1-11 Australia Avenue, Sydney Olympic Park

Prepared for **Site 3 Development Company Pty Ltd**

Major Project MP10_0027
Preferred Project Report

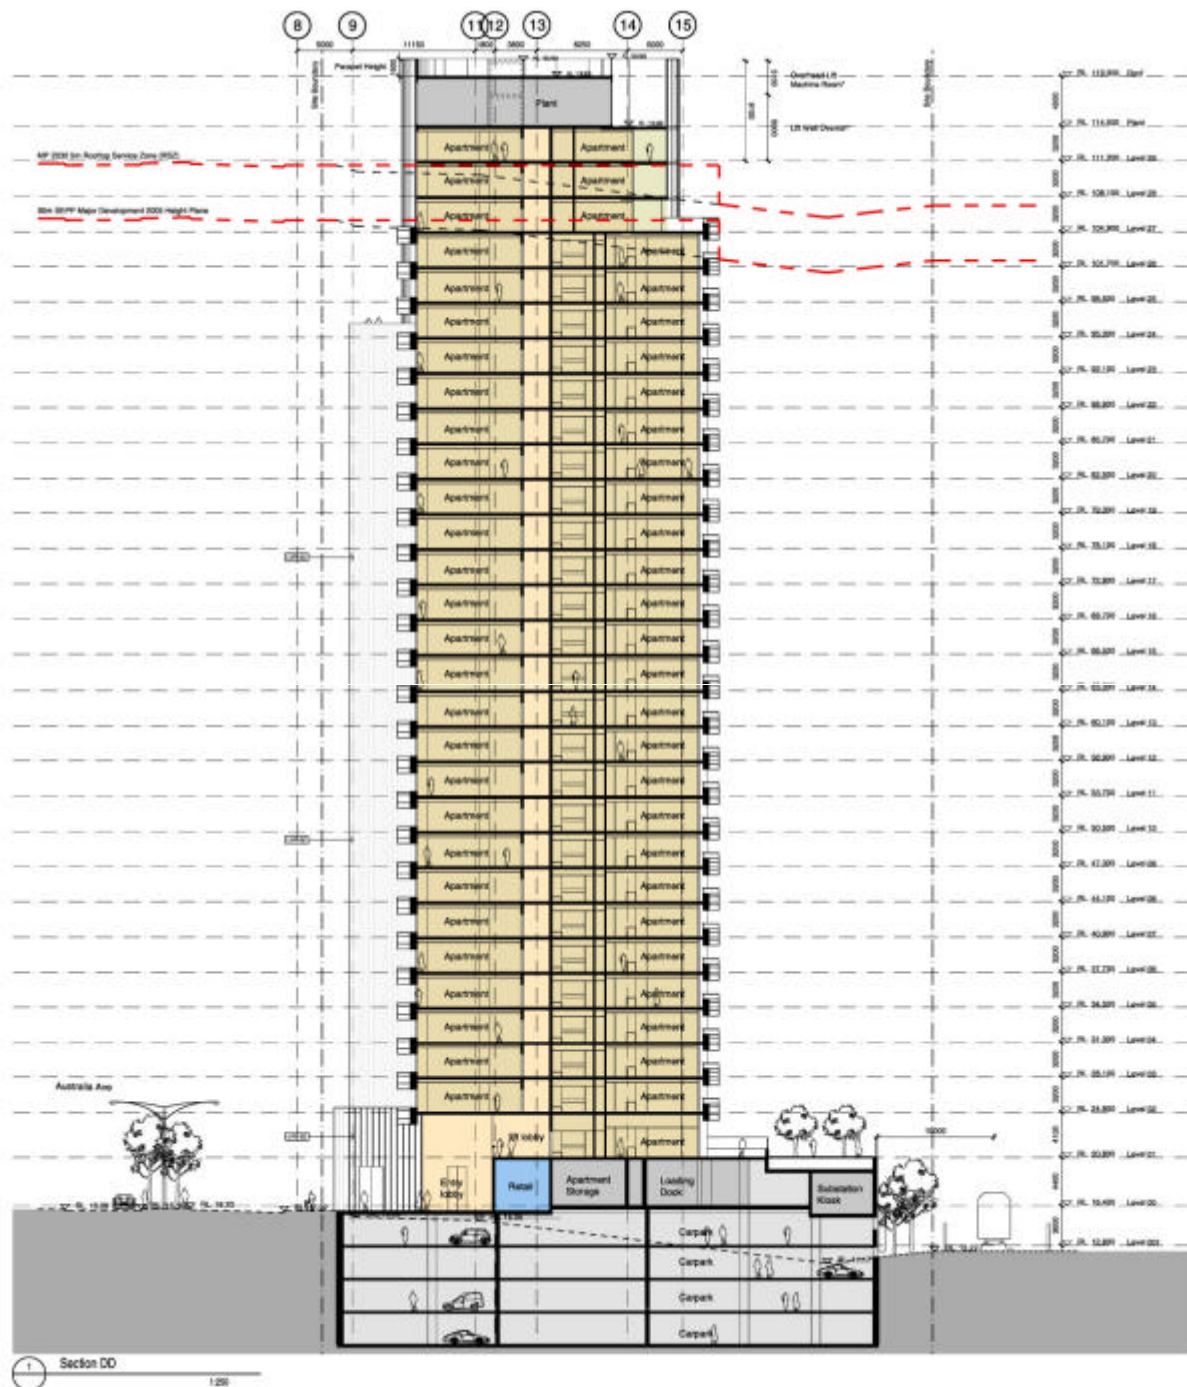
Issue	Response
1. Clarification regarding the maximum height of Towers 1 and 2 above existing natural ground level.	Existing ground level is shown on the architectural sections submitted in the Environmental Assessment. For clarity the Architects Bates Smart have updated these sections to show the maximum height limit, which is measured to be 90 metres above existing natural ground level. Refer to Figure 1 and Figure 2. Building height (or height of building) is defined in Part 23 of the Major Development SEPP to mean: <i>"the vertical distance, measured in metres, between ground level (existing) at any point to the highest point of the highest habitable floor (including above ground car parking) of the building, excluding plant and lift overruns, communication devices, antennae, satellite dishes, masts, flagpoles, chimneys, flues and the like"</i>. Tower 1 has a maximum height measured in accordance with the Major Development SEPP definition of 84.06m, which complies with the maximum 90m height limit. Refer to Figure 1 showing the height limit of the overall development including roof plant and the height limit excluding roof plant zone. Tower 2 has a maximum height of 99.45m measured in accordance with SEPP definition. The additional height of Tower 2 is justified having regard to the Clause 21 of the LEP, which allow variations to development standards to be considered by the consent authority, where it can be justified that: (a) <i>compliance with the development standard is unreasonable or unnecessary in the circumstances of the case, and</i> (b) <i>there are sufficient environmental planning grounds to justify exempting the development from that development standard.</i> Compliance with the Development standard is unreasonable and unnecessary as the proposed development is no higher than the tallest building ('Building D') that was previously approved for the site under the Staged Master Plan DA 246-10-2004. Tower 2 is no greater in height than the tallest residential tower approved under the Staged Master Plan DA246-10-2004, although it is proposed in an alternative location on the site further south on the site. The approved tower building C/D had a maximum height of 114.5m RL excluding roof plant zone and RL 120.6m including the roof plant zone.

The maximum height of Tower 1, measured in accordance with the Major Development SEPP definition is 84.06m. Tower 1 complies with the 90 metre maximum height limit under the Major Development SEPP.

Figure 5. Tower separation analysis diagram Tower 1 to 2
Prepared by Bates Smart.

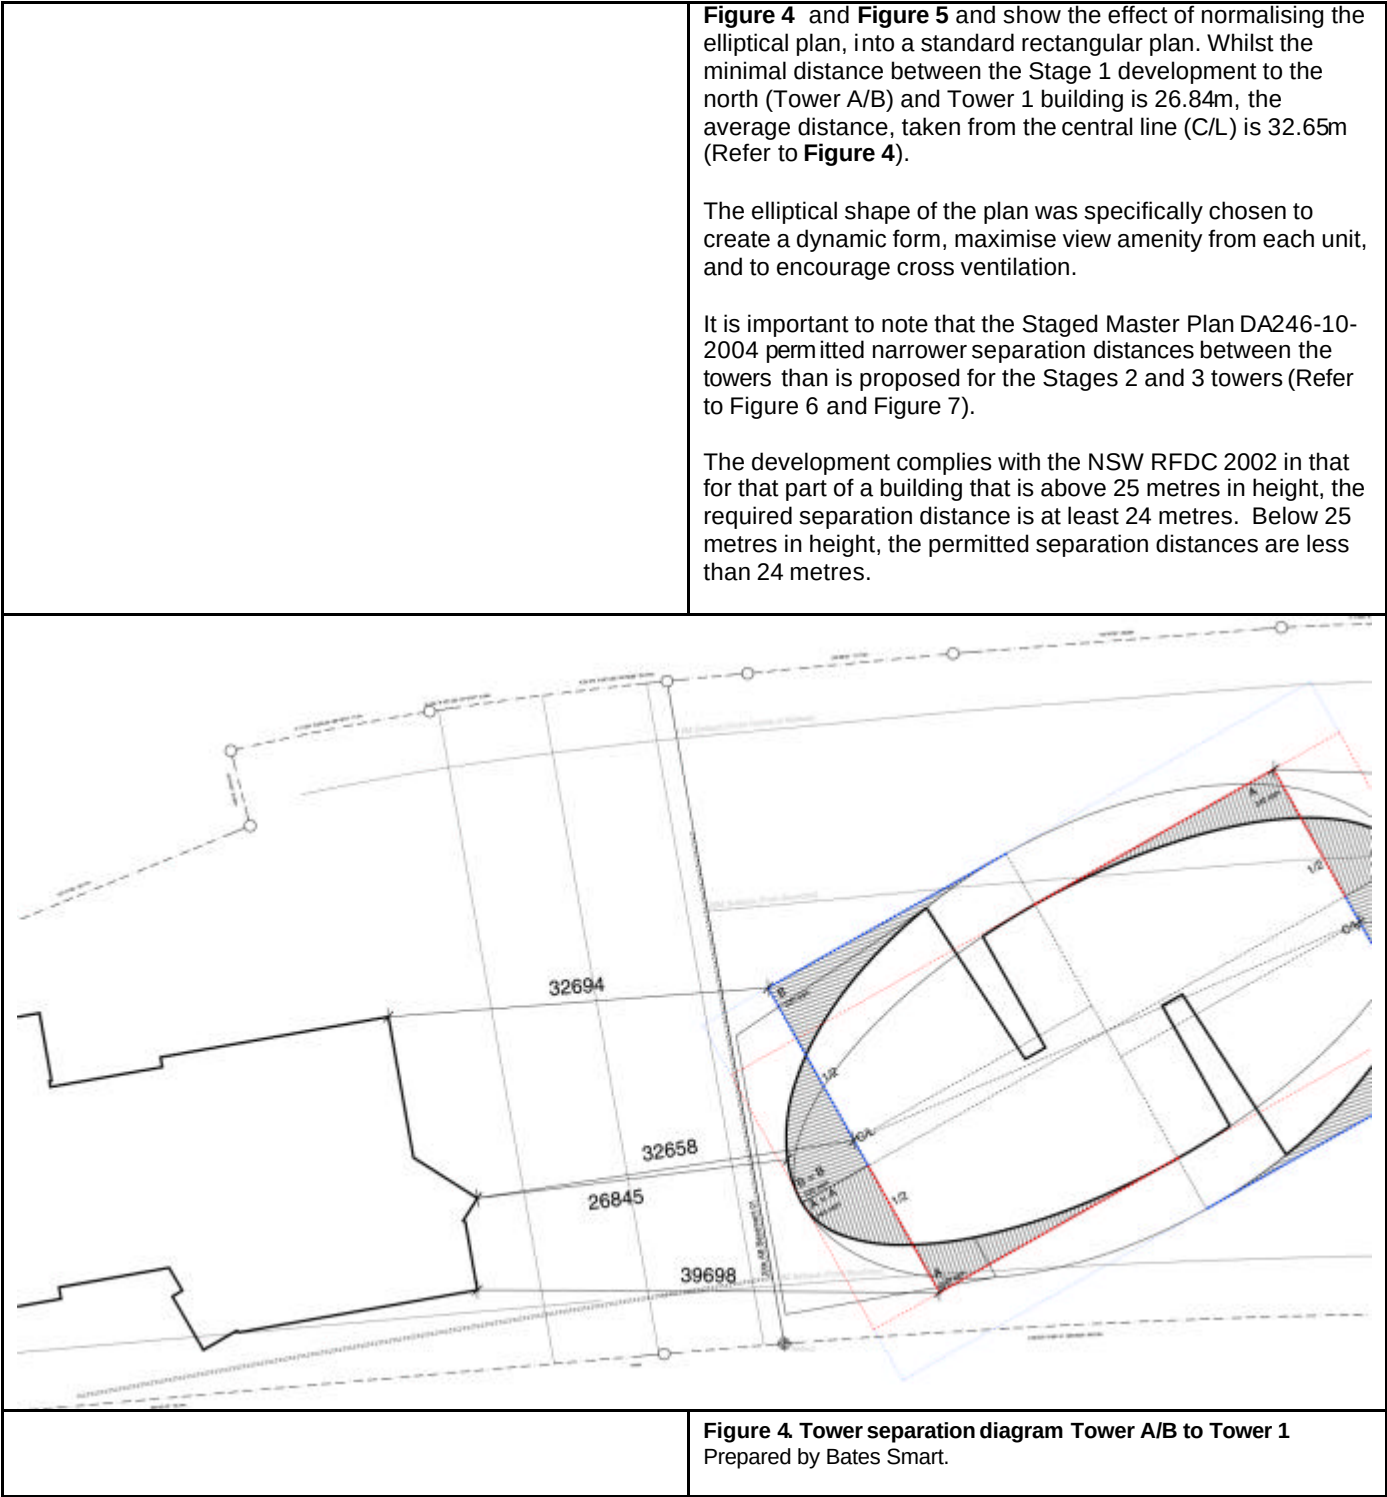
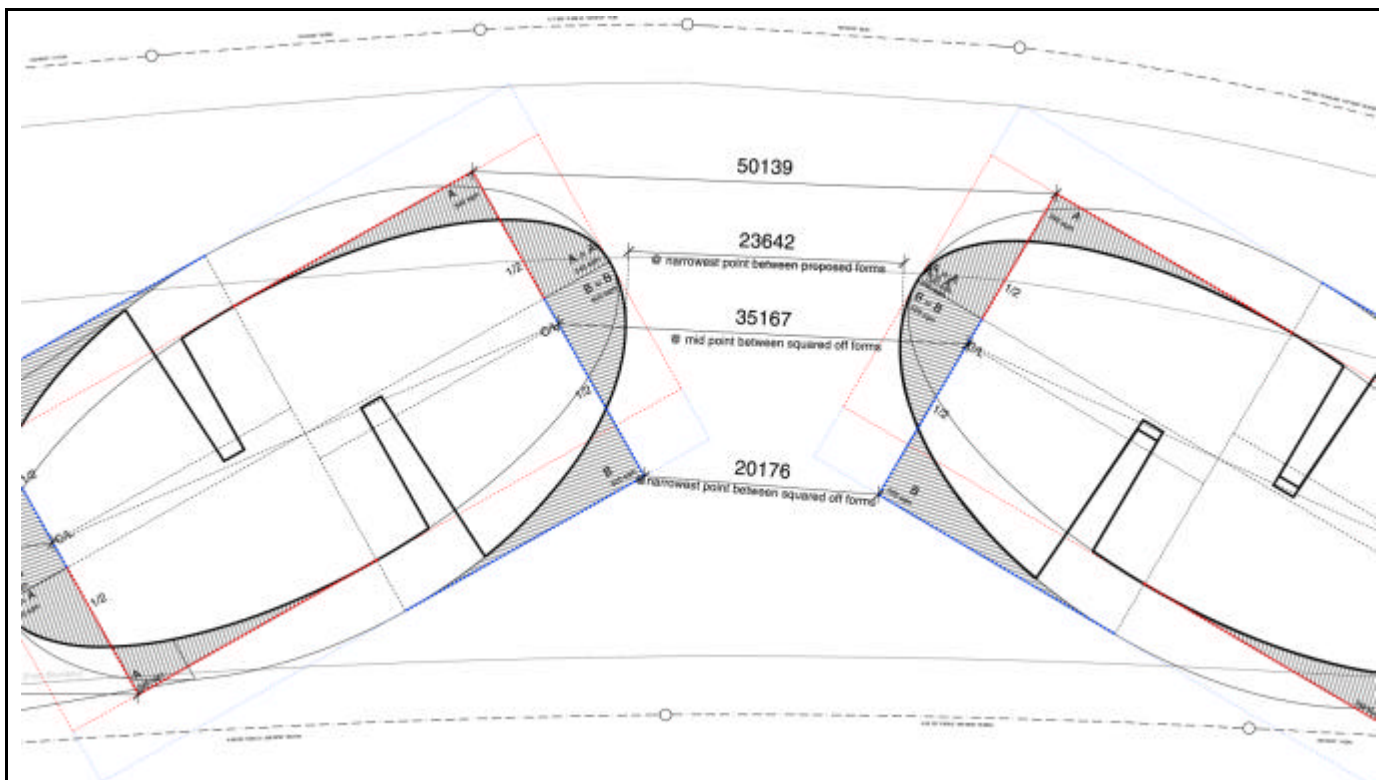
3. Clarification regarding compliance with tower separation requirements in the Sydney Olympic Master Plan 2030, or provide justification for any non-compliance.	The design competition endorsed two towers instead of three for the Stages 2 and 3 site. The sitting of the towers was supported by the Design Competition Jury in selecting the scheme to progress to the Project Application phase. The support of the tower locations is expressed in the Jury Report on page 9, as follows: <i>"From long distance the tower separation and differentiation in tower heights provided a desirable articulated skyline. The proposal for two towers allowed for greater separation and visual connections through the site"</i> The intent of the separation distance control, as outlined in the NSW RFDC 2002 is to: - Ensure that new development is scaled to support the desired area character with appropriate massing and spaces between buildings - To provide visual and acoustic privacy for existing and new residents; - To control overshadowing of adjacent properties and privacy or shared open space. - To allow for the provision of open space with appropriate size and proportion for recreational activities for building occupants; - To provide deep soil zones for stormwater management and tree planting, where contextual and site conditions allow. The deletion of Tower E from the approved Staged Master Plan DA 246-10-2004 at the southern end of the site created an open space in this Stage 2 and 3 Project Application for common use by residents and their visitors and has opened up the public view along Figtree Street to the east and south east. This space allows for additional deep soil landscaping and the retention of existing stormwater infrastructure, which would not have been possible if the site was to be developed in accordance with the Stage 1 Master Plan DA 246-10-2004. Living rooms are not directly facing each other in this location due to the skewed orientation of the buildings, which will limit direct overlooking opportunities and visual and acoustic privacy impacts. The proposal achieved the minimum solar access requirements under the Master Plan 2030 and the NSW RFDC 2002. The 24m separation distance occurs only at the closest point between Towers 1 and 2. A diagram has been prepared by Bates Smart Architects to illustrate the separation distance between the two towers. Refer to Figure 4 and Appendix B.

Figure 1 shows the effect of normalising the elliptical plan, into a standard rectangular plan for Stages 2 + 3. Whilst the minimal distance between the two buildings is 23642mm, the average distance, taken from the C/L of the squared off forms is 35167mm.

A 40m setback is proposed in MP2030 is to prevent overlooking between facing buildings. The towers proposed in Stages 2 + 3 are orientated on a north-south axis and are angled away from each other, meaning the living spaces in the units are orientated away from the neighbouring building.

Figure 8. DA 246-10-2004 building massing
View corridors showing diagrammatically from 1 Figtree Place.

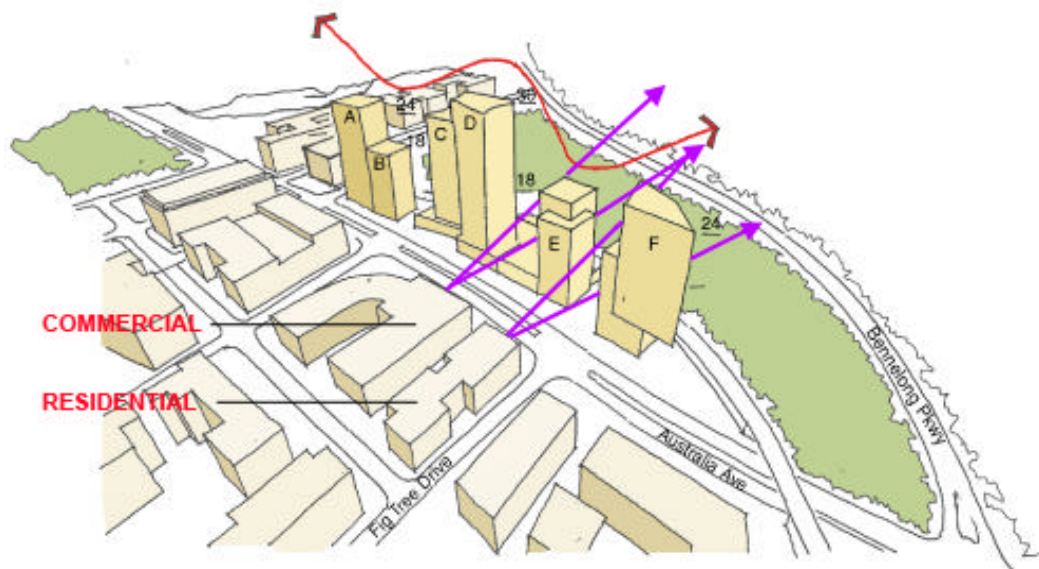
2	View loss The EA does not provide any diagrams or visual aids such as a photomontage to demonstrate visual impacts of the proposed building envelopes. As such, further view analysis is required to adequately consider view loss impacts from 1 Figtree Drive and other key viewing locations.	Key view corridors are identified in the Master Plan 2030 in Figure 3.2 with easterly views to Sydney CBD and Chatswood The siting of the two towers proposed for Stages 2 and 3 of the site are consistent with the Design Competition winning scheme. The Staged Master Plan DA 246-10-2004 for the site proposed three buildings for Stages 2 and 3 area of the site (Refer to Figure 8 and Figure 9). The proposal included two towers and removes the building (Building F) which was intended to be located at the southern end of the site and replaces it with Fig Tree Place (common open space). Refer to Figure 10. This change will result in an improvement of the views from 1 Figtree Place towards central Sydney, when compared with the building envelopes approved under the Stages Master Plan DA particularly from the southern part of 1 Figtree Place, which under the Master Plan 2030 is designated for a 10 Storey residential building(s). Views across the site to the north east and east to Chatswood may be impacted worse from 1 Figtree Place with this proposed Stages 2 and 3 buildings, however the improvement in the views to Central Sydney compensates for this.
